**SUBJECT: Negative Declaration for Hilton Lagoon Project,
Hilton Hawaiian Village, Waikiki, Oahu**

1995-03-08-0A-FEA - Hilton Hawaiian Village Lagoon Project

Final
Environmental Assessment
for the
Hilton Lagoon Project
Hilton Hawaiian Village
MAR - 8 1995

Figure 2. Composite of several maps to show relationships between parcel boundaries, the Kahanamoku Lagoon, and the proposed Hilton Lagoon project.

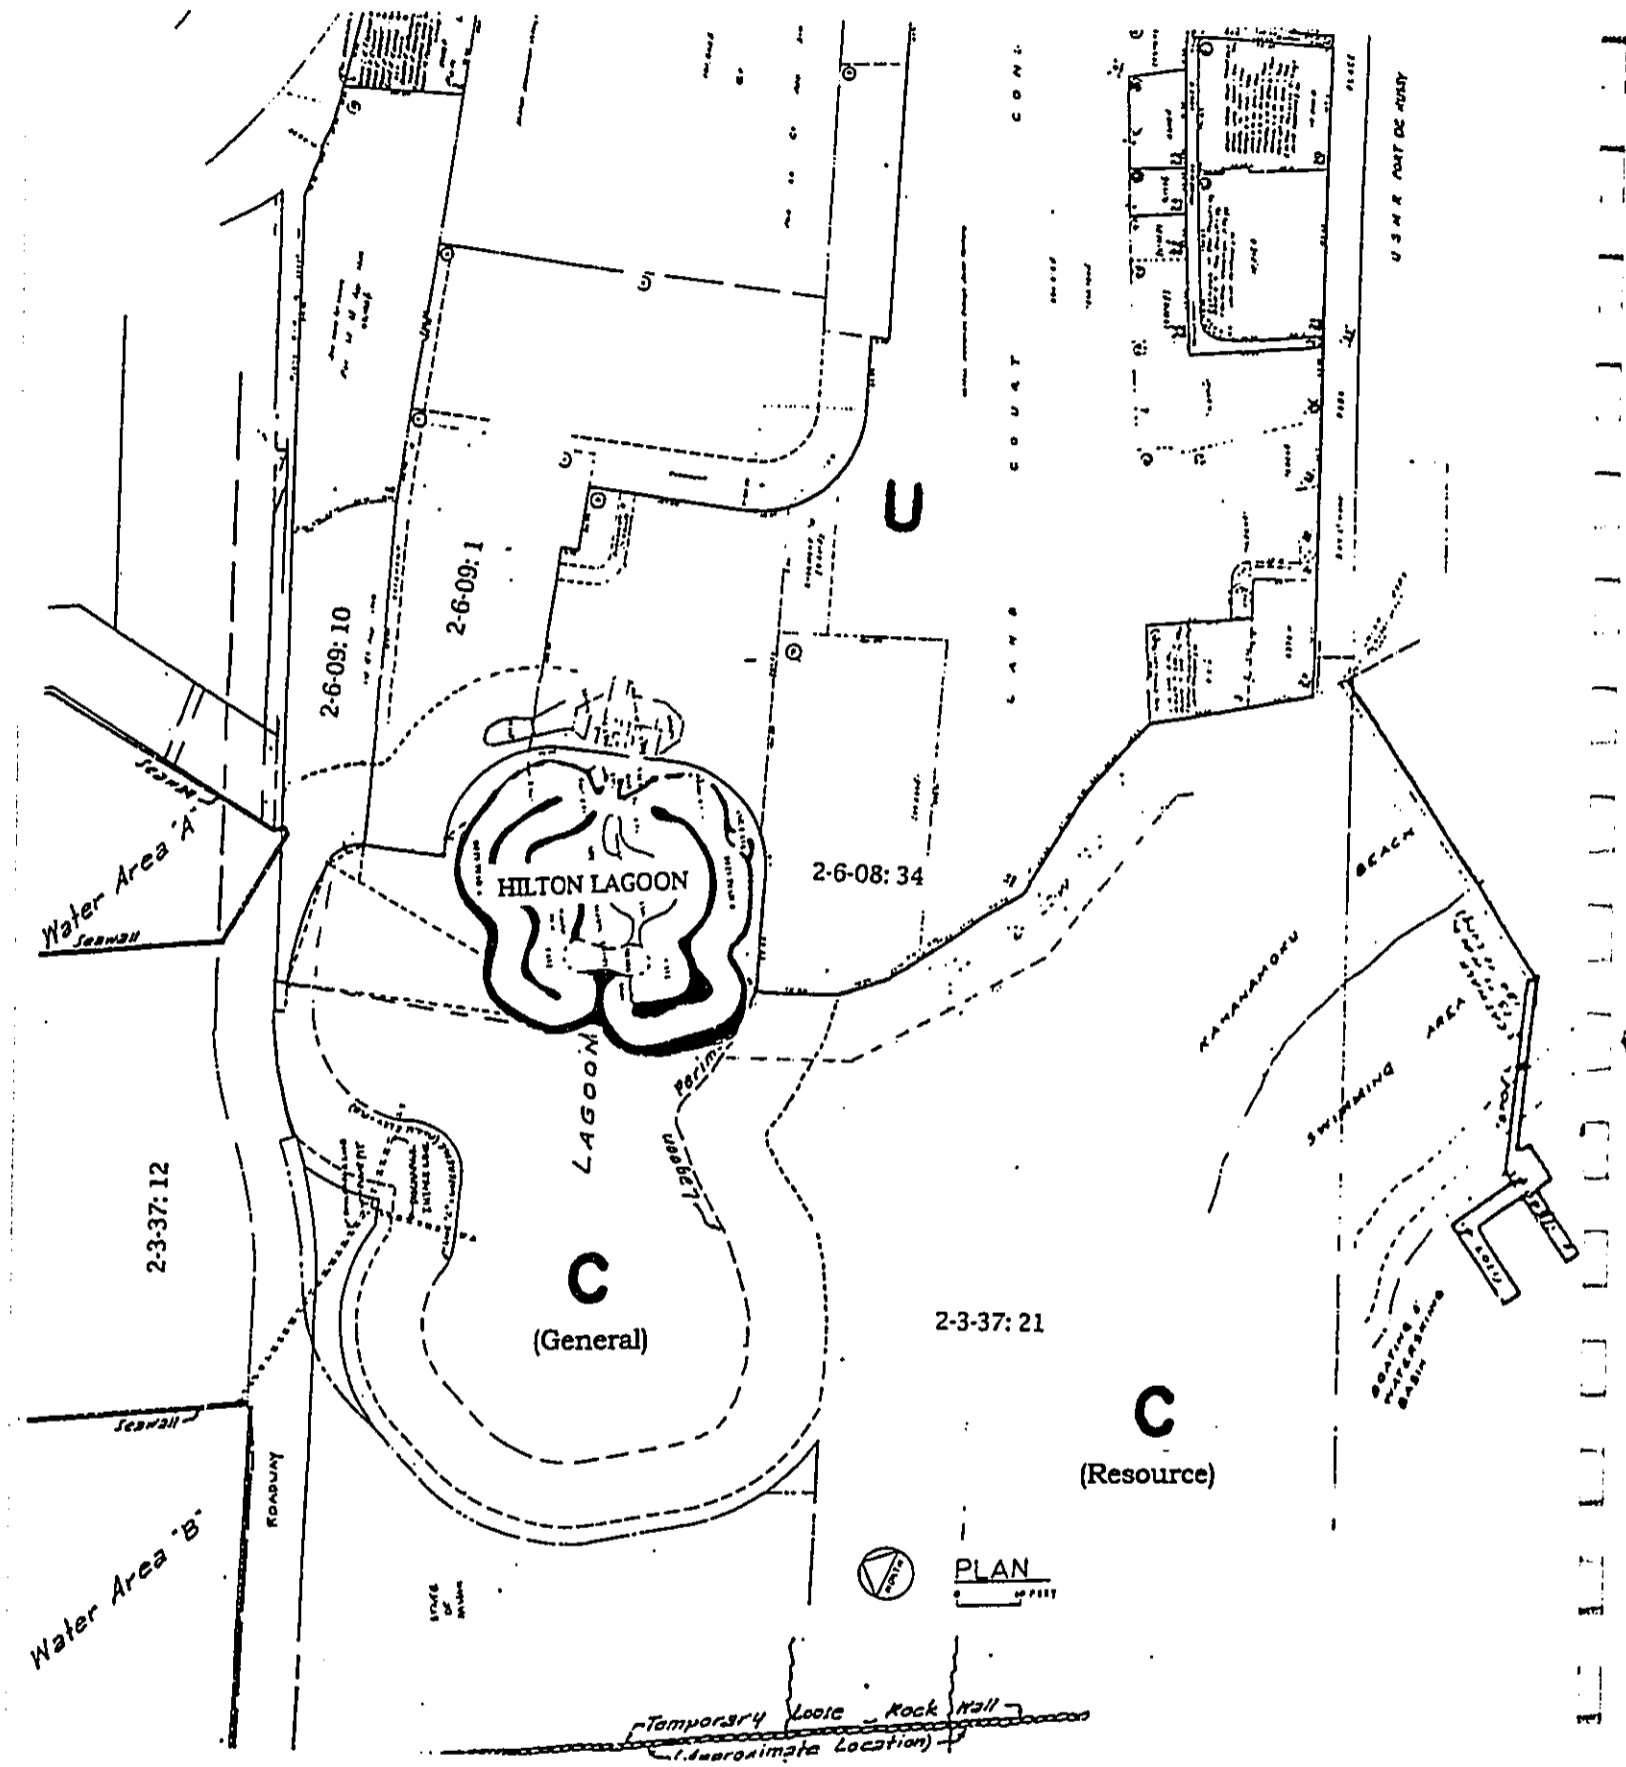
6. Comment: *It is unclear on Figure 2, page 6, what State Land Use District the Kahanamoku Beach area is in. Is it also the Conservation District?*

Response: All ocean shoreline beaches in the State of Hawaii are in the Conservation District and Kahanamoku Beach (which is the west end of Waikiki Beach) should be no exception. An attempt was made to clarify the boundaries of the conservation district relative to the lagoon since it is possible that the certified shoreline could cross between the lagoon and Kahanamoku Beach or could curve around the outside of the lagoon. State records (Land Use Commission) provide no more detail than is shown in Figure 2 of the FEA, indicating only that the lagoon is in the State Conservation District.

1) We have included in the final EA a map (as Figure 2) which relates property boundaries and zoning to the proposed project layout. Our Figure 6 shows the existing lagoon and adjacent parking and beach areas.

4) Figure 2 will be modified to provide the information requested as part of the permit application.

Figure 6
 Plan and sectional views of the
 Hilton/EnterOcean complex

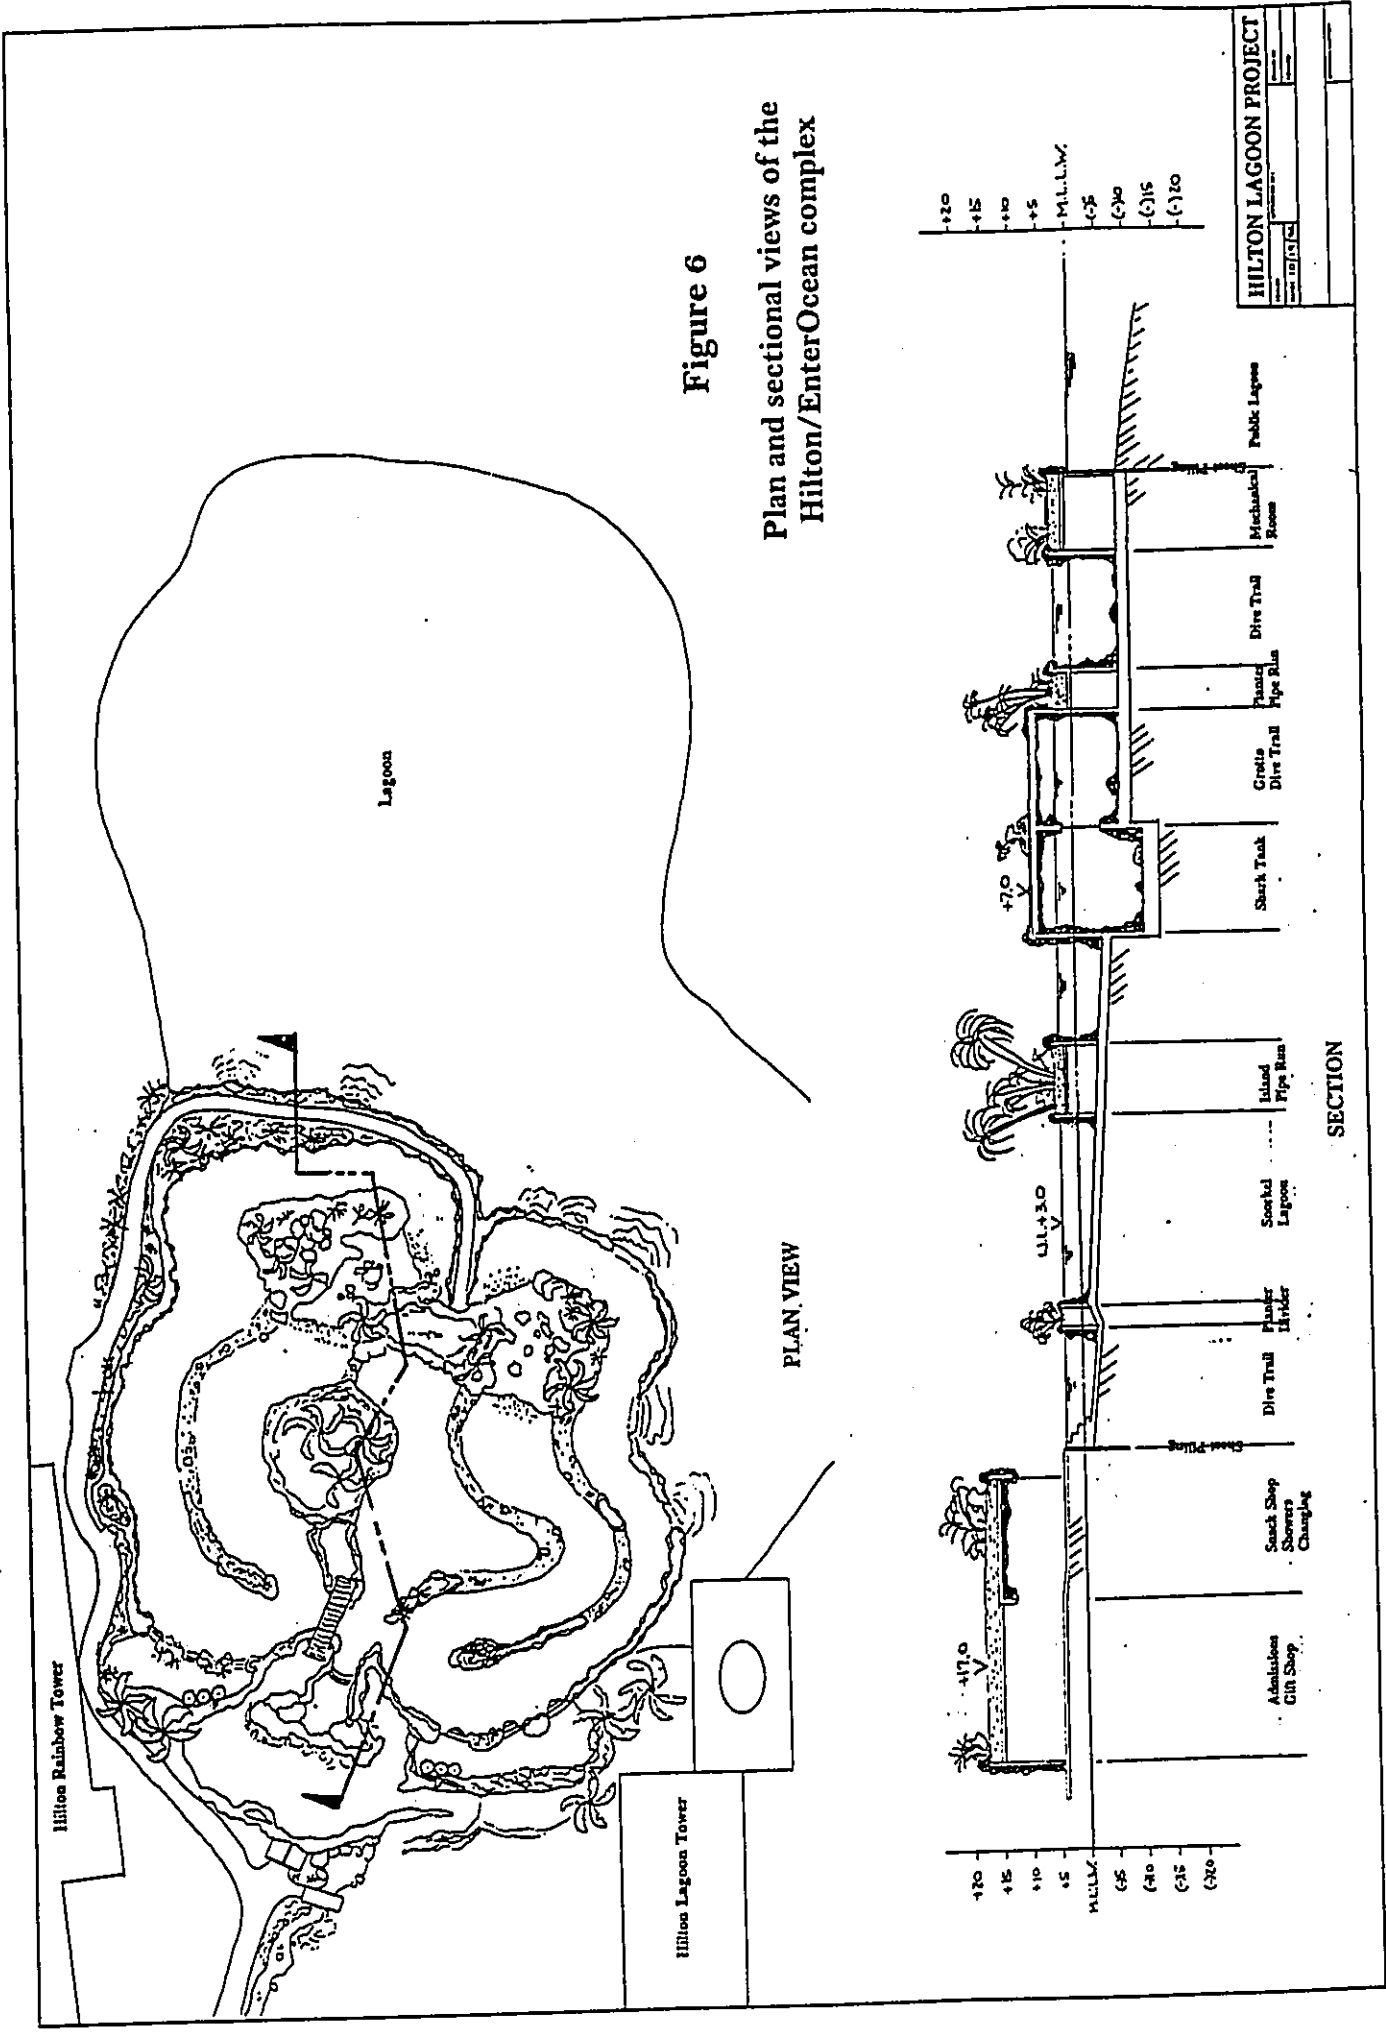
7. Comment: *Figure 6 on page 16 should have a legend identifying the different symbols for the intake and discharge pipes.*
